# Addendum No. 1

## Rock River Water Reclamation District Substation 3-6 Electrical Upgrades Capital Project No. 2023

**ROCK RIVER WATER RECLAMATION DISTRICT**  
**SUBSTATION 3-6 ELECTRICAL UPGRADES**  
**CAPITAL PROJECT #2023**

SHEET E108

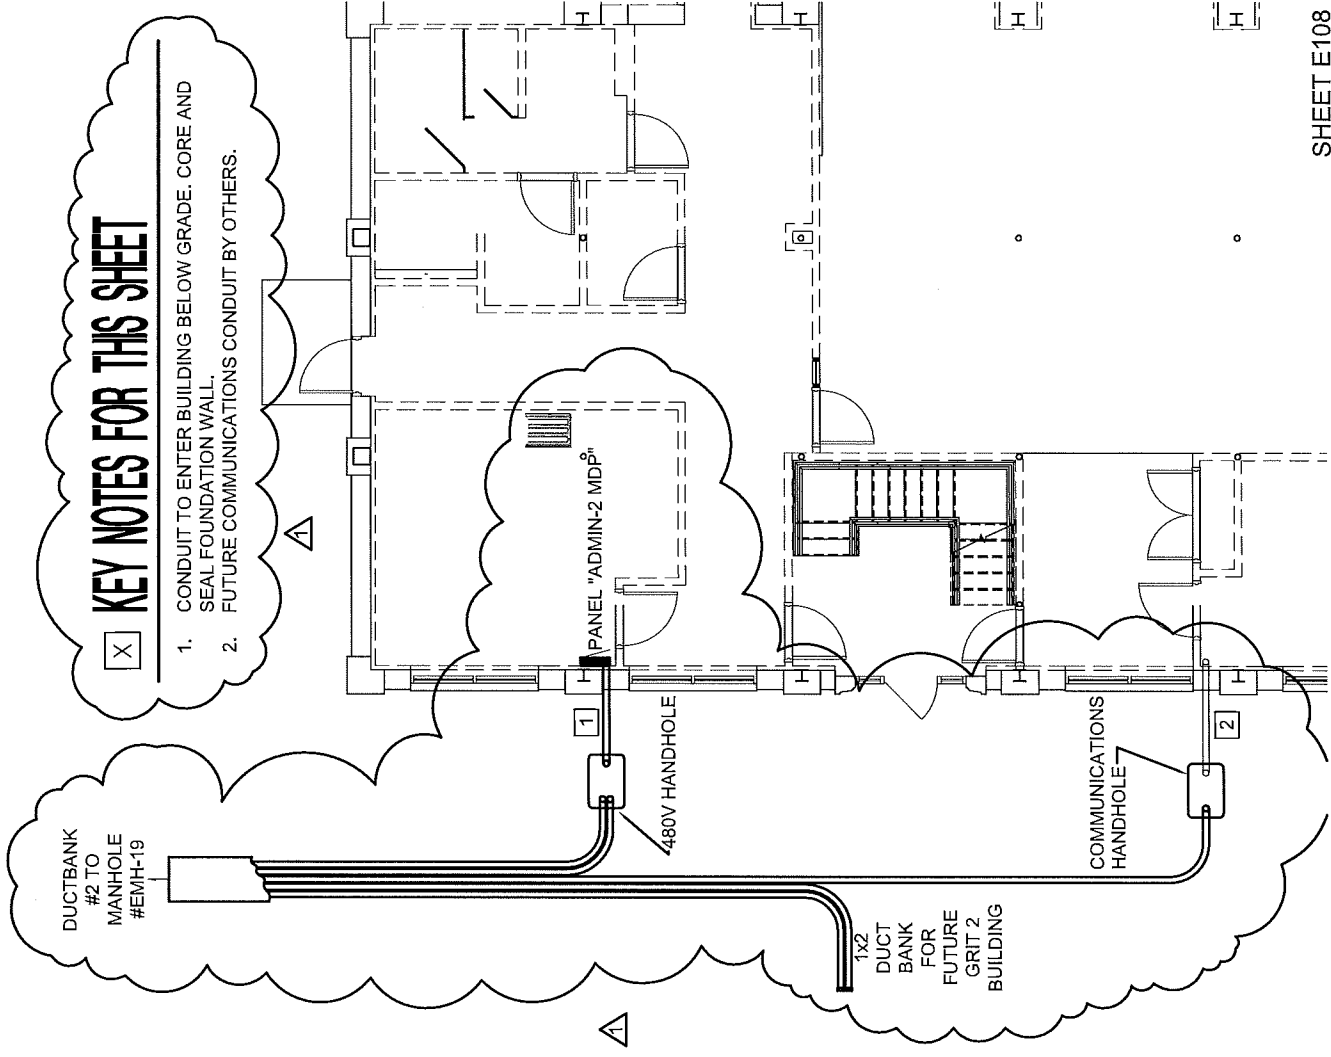
1. The following plan sheets have been revised. Revised plan sheets are attached and shall replace original plan sheets:
  - a. Drawing E104 has been updated to reflect a change in the entry point for the 480V duct bank re-feed to the Admin 2 Building.
    - i. One electrical hand hole and one communications hand hole has been added. See attached Sheet ADE1.1.
    - ii. Notes #13 and #19 have been revised to reflect the changes to the Admin 2 Building duct bank re-feed. See attached Sheet ADE1.2
  - b. Drawing E108 has been updated to reflect changes in the panel and conduit entry locations. See attached Sheet ADE1.3

- c. REPLACE Keynote Note #1 on Drawing E108 as follows:  
CONDUIT TO ENTER BUILDING MINIMUM 2'-0" BELOW GRADE. PROVIDE DOUBLE  
LINK SEAL(INNER/OUTER) ON 24" THICK FOUNDATION WALL AND SEAL  
CONDUITS PER SECTION 25 05 43. COMPLETELY REMOVE EXISTING WOODEN  
STORAGE STRUCTURE TO ALLOW FOR NEW CONSTRUCTION.
